Addendum No. 3
Date: February 16, 2026

Project:
Addition to
Andalusia Elementary School for the
Andalusia City Schools
Andalusia, Alabama

MCKEE PROJECT NO. 24-304
ALABAMA DIVISION OF CONSTRUCTION MANAGEMENT NO. 2025681

L WALL SECTION
SCALE: 3/4"=1'-0"

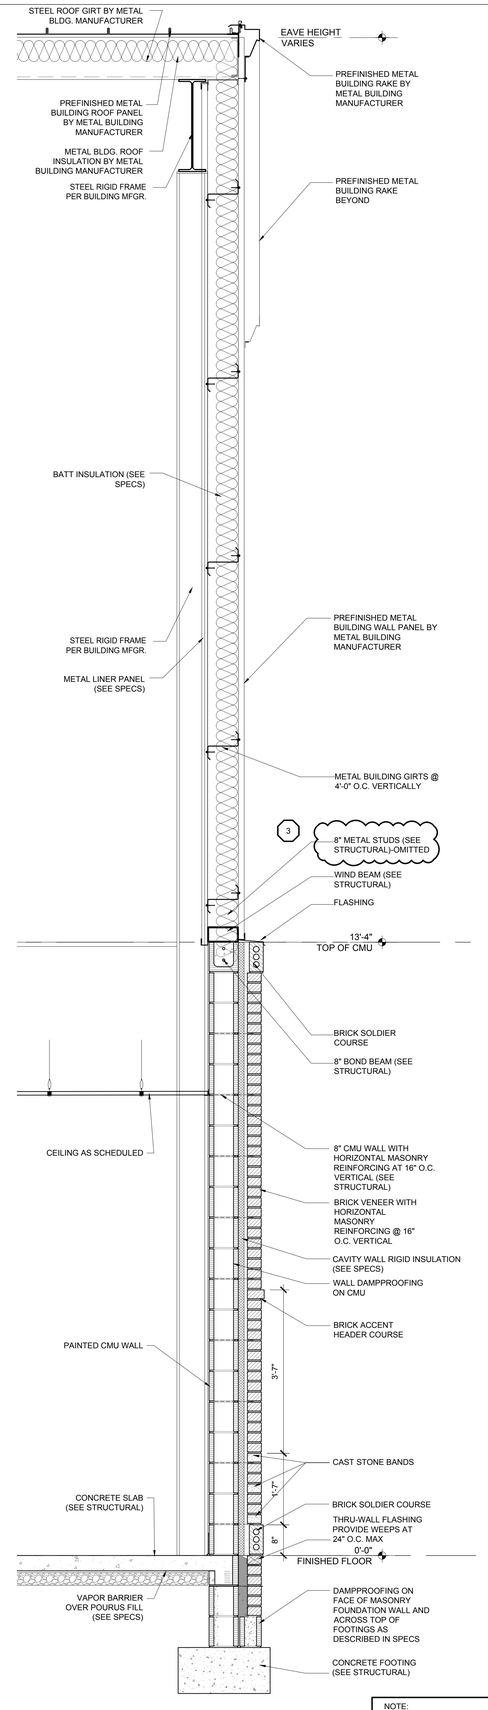
On sheet A6.3 wall section L, it shows what appears to be 8" metal studs between the PEMB wall girts. It notes to see Structural. Structural drawings do not show these metal studs. Should this wall just be a PEMB wall with liner panels on the interior and exterior wall panels on typical wall girts? Infilling between the girts with metal studs is going to be very costly. Insulation shown is presumed to be typical Simple Saver insulation. Please clarify if 8" stud infill is required.

Response: 8" metal studs are not required between the PMB wall girts – See revised wall section sheets attached herein.
